# PRODUCT CHANGE NOTIFICATION

REVISED October 20, 2022

### Bourns® Model CDSOD323-Txxx Series TVS Diode Arrays *Additional Assembly and Test Manufacturing Location*

## Typical Part Marking

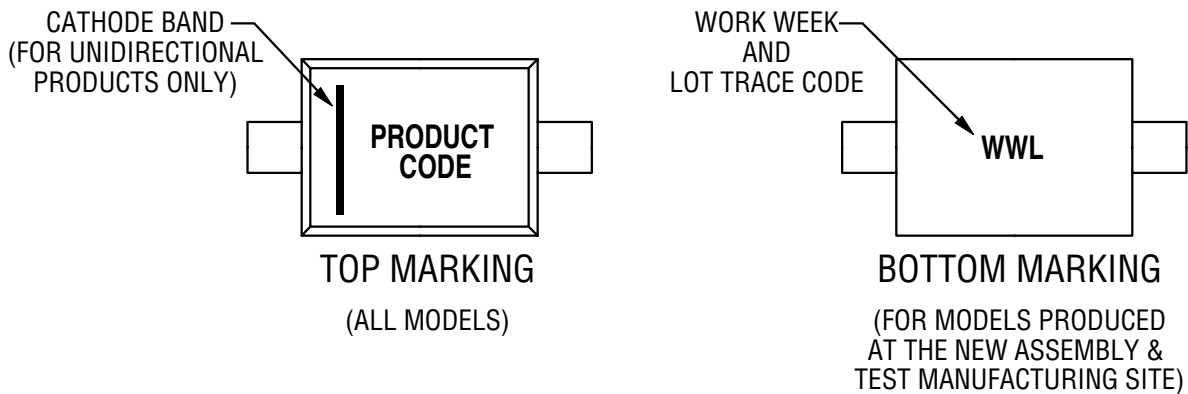
The bottom part marking will be used to identify units produced at the new assembly and test manufacturing site. The bottom marking will include the Work Week (WW) and Lot code (L) in alphabetic characters while the current existing site will use only the top part marking.
